PROJECT: Sequoya Commons – Phase I
Madison, Wisconsin

RE: Revised Urban Design Documents

Due to value engineering that has taken place since this project was given final approval, we are resubmitting Sequoya Commons for an Urban Design Commission review. Attached to this letter are 14 sets of revised drawings and the application for Urban Design Commission review on April 11, 2007. A disk with PDF files of this re-submittal is included.

Roof Plan

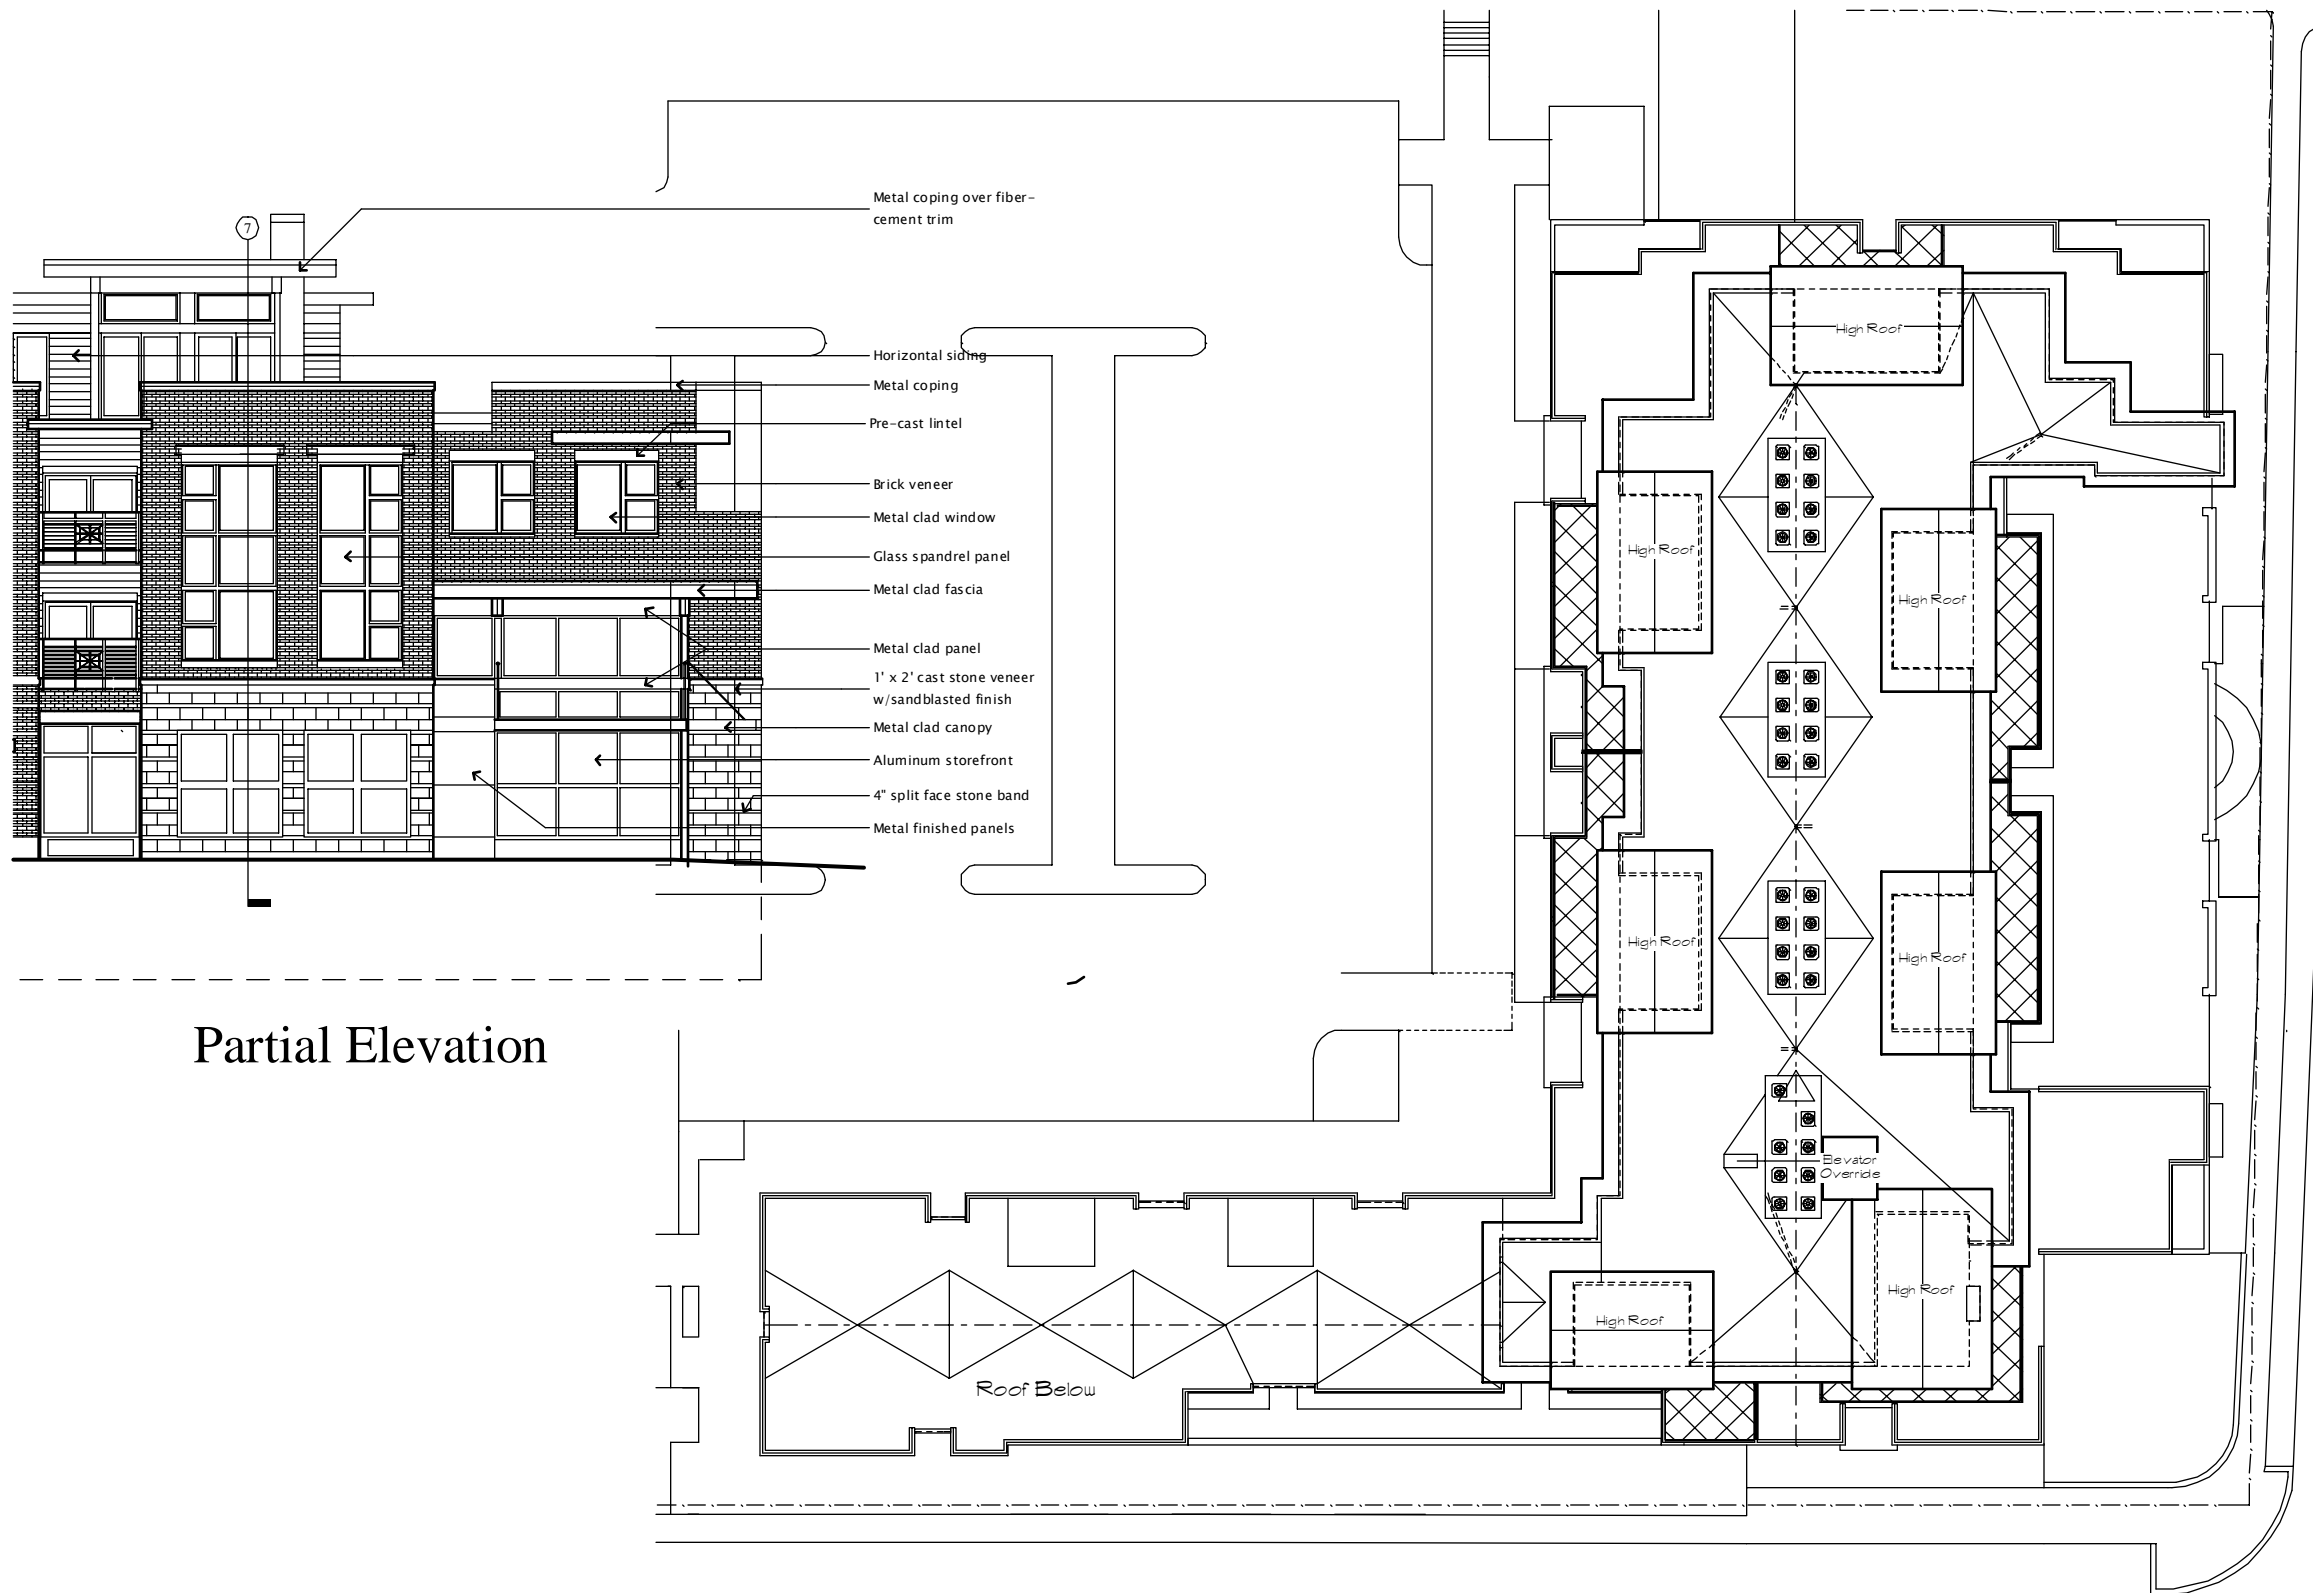
9. Six of the seven chimneys at the fourth level have been removed.

4
H-2 Scored Concrete Pattern at Midvale Blvd. and Tokay Blvd.
Scale: 1/4" = 1'-0"

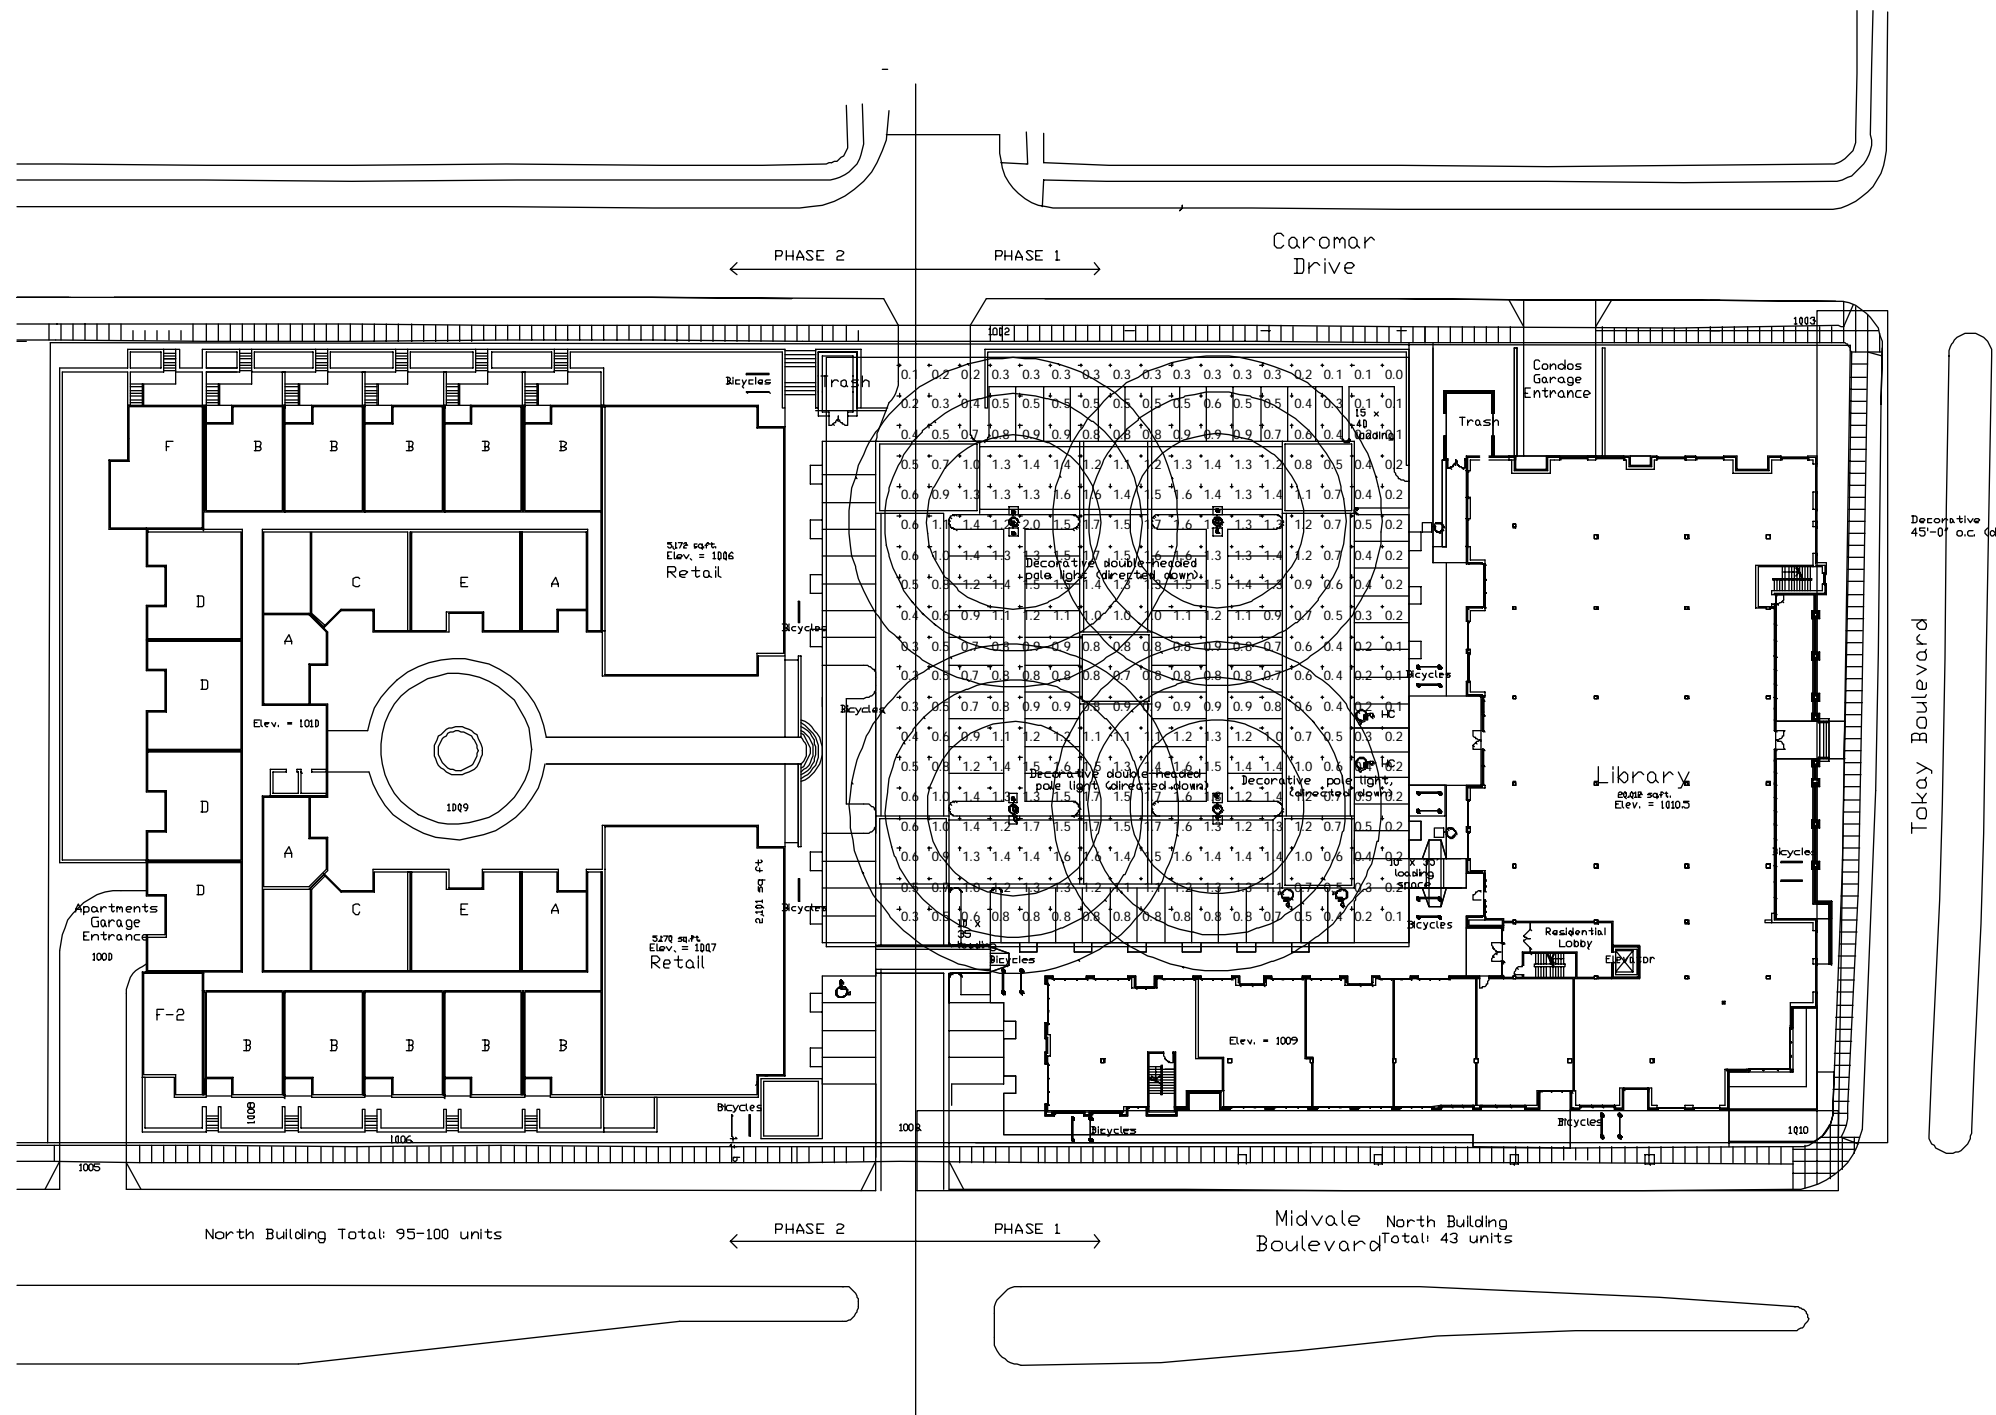
3. The hardscape area at the south west corner (at the corner of Midvale Blvd and Tokay Blvd) has been re-designed to reflect city engineering's requirement that the public sidewalk be of continuous concrete construction per City of Madison standards.
